ATTACHMENT 2

PROPOSED REVISIONS  
TECHNICAL SPECIFICATIONS

SOUTH TEXAS - UNIT 1

PROPOSED REVISIONS

Figure 7.2-7

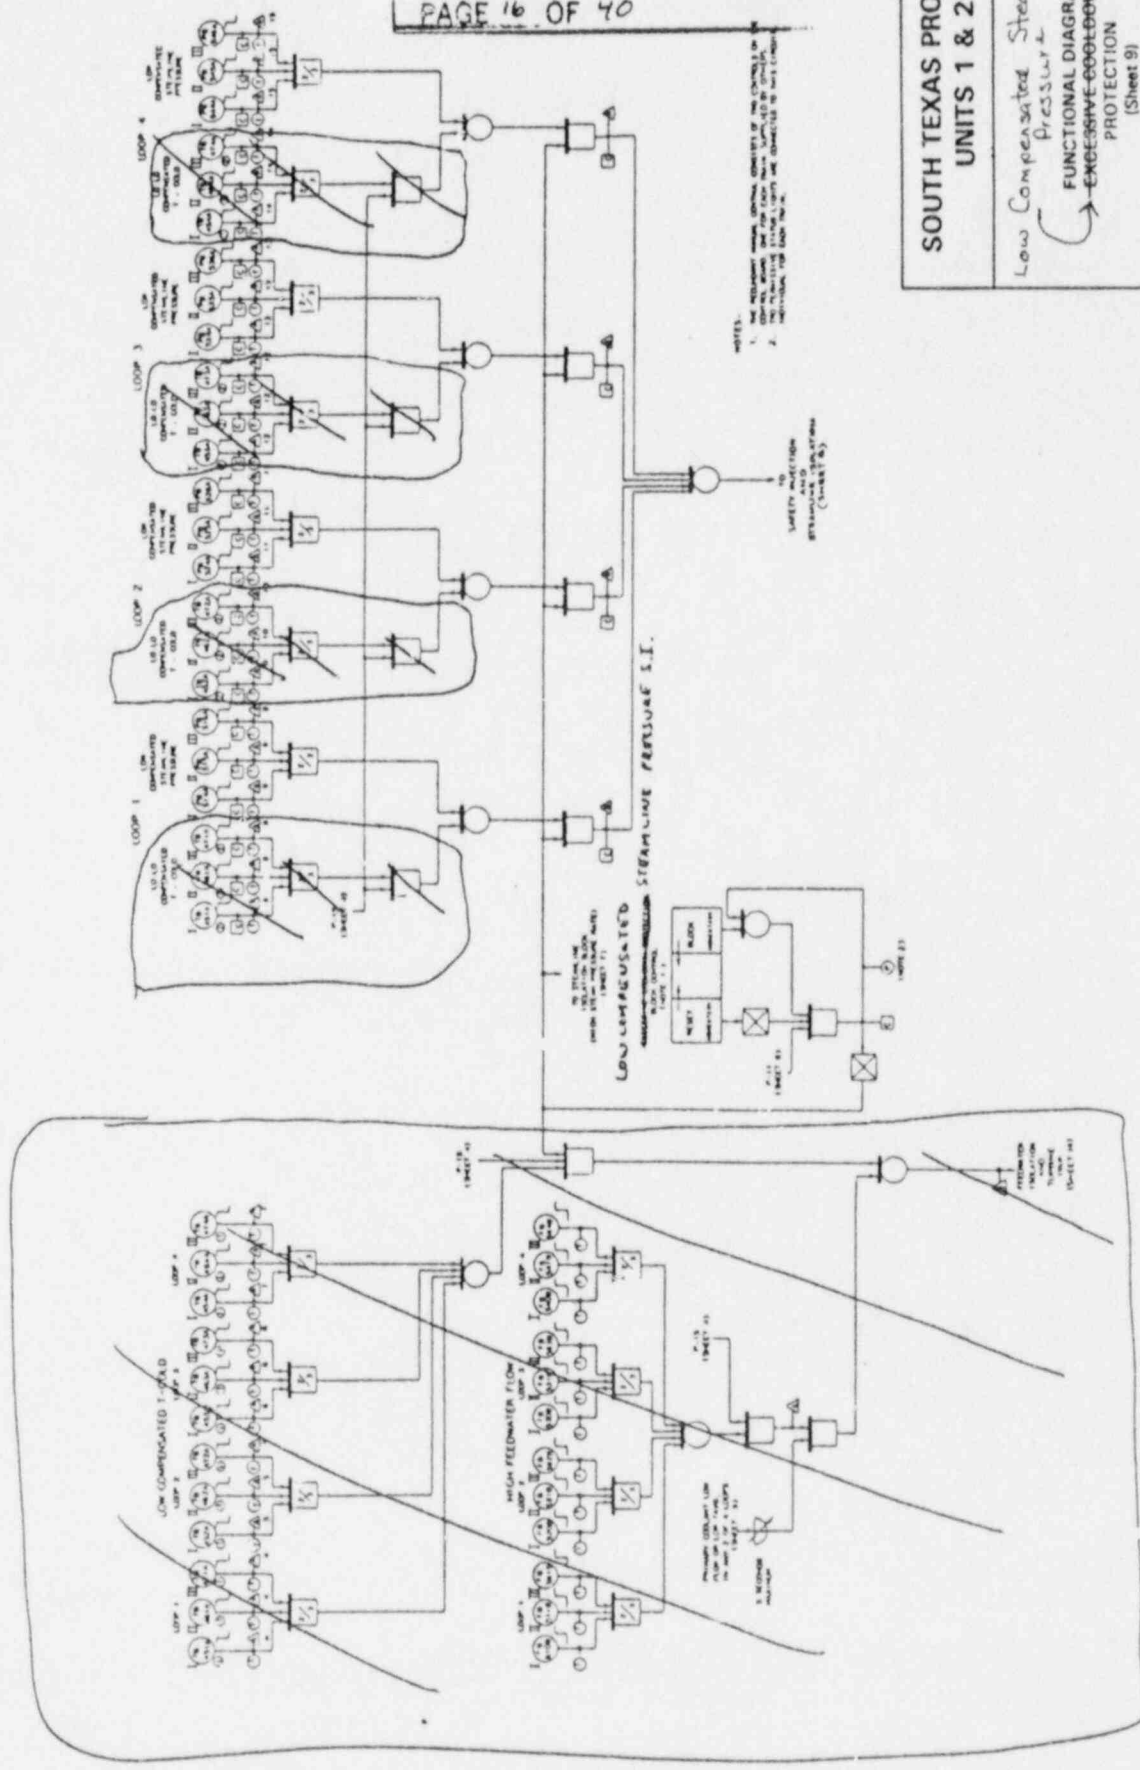
2. Steam Generator High-High Water Level Signal (Figure 7.2-7)	2. Four channels are used for each SG (2/4 logic) on STP; three channels are used for each SG (2/3 logic) on Comanche Peak.

Figure 7.2-14

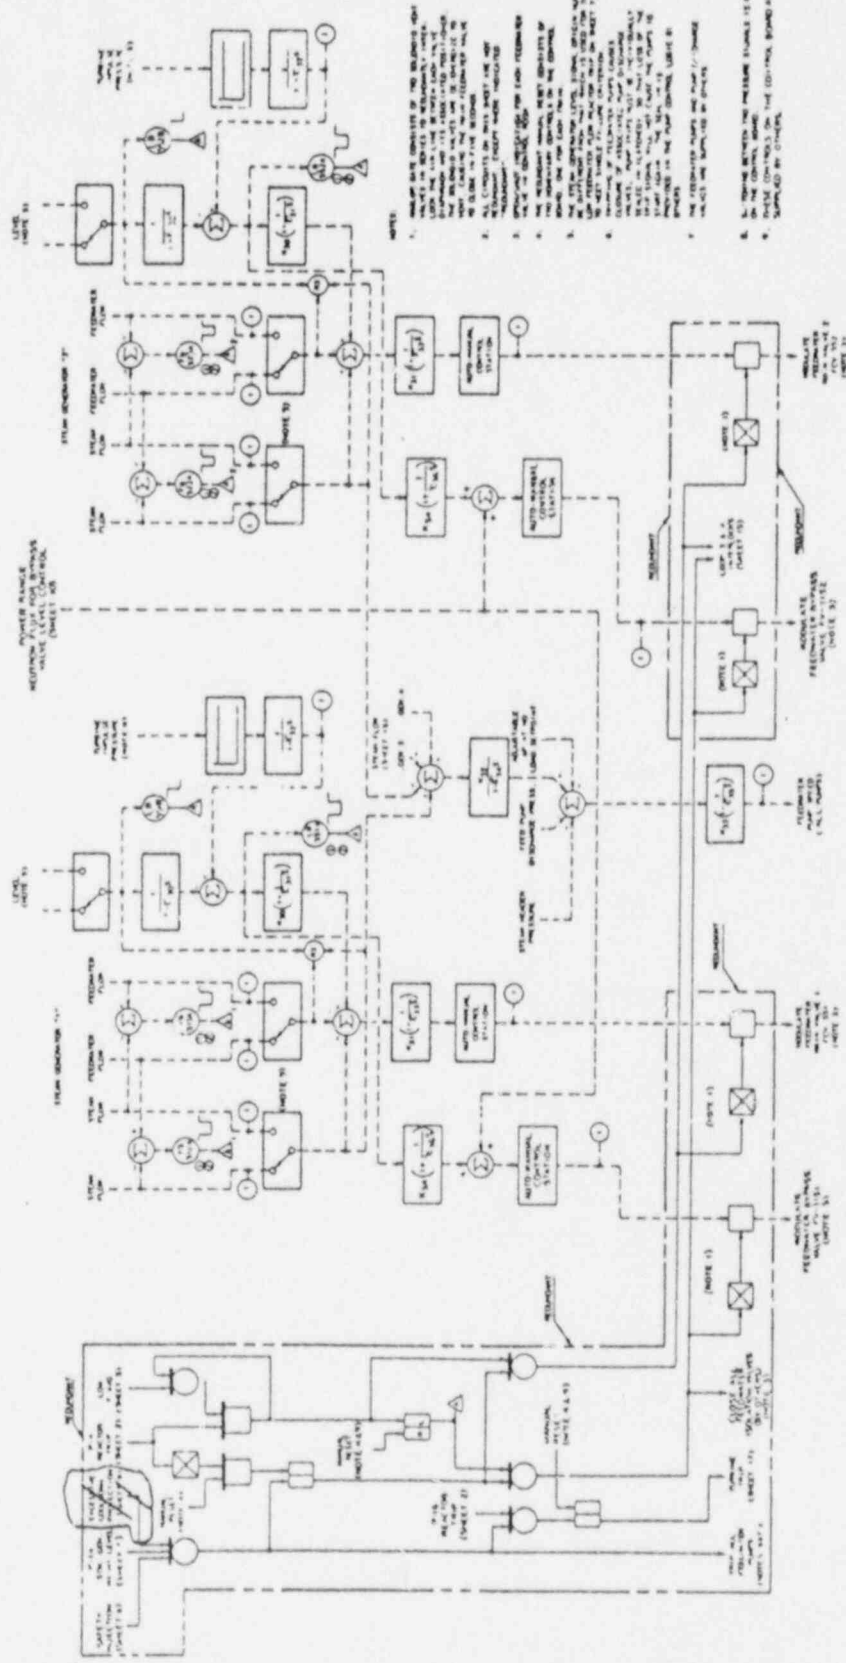
| 11. | Turbine Trip Signal From Feedwater Isolation Signals (Figure 7.2-14)  | 11. | Addition on STP of manual reset capability for the turbine trip signal from the combined signal of P-16 or any of the following signals: safety injection or P-14 signal, <del>or excessive cooldown feedwater isolation.</del> Comanche Peak does not provide this capability.  |    |

12. P-4 Signal/Safety Injection or P-14 Signal or ~~Excessive Cooldown~~ Feedwater Isolation Interface (Figure 7.2-14)

STP: The SI signal or P-14 signal or ~~excessive cooldown~~ FW isolation signal sets a retentive memory for FW isolation. Absence of a P-4 reactor trip then allows reset of the memory.
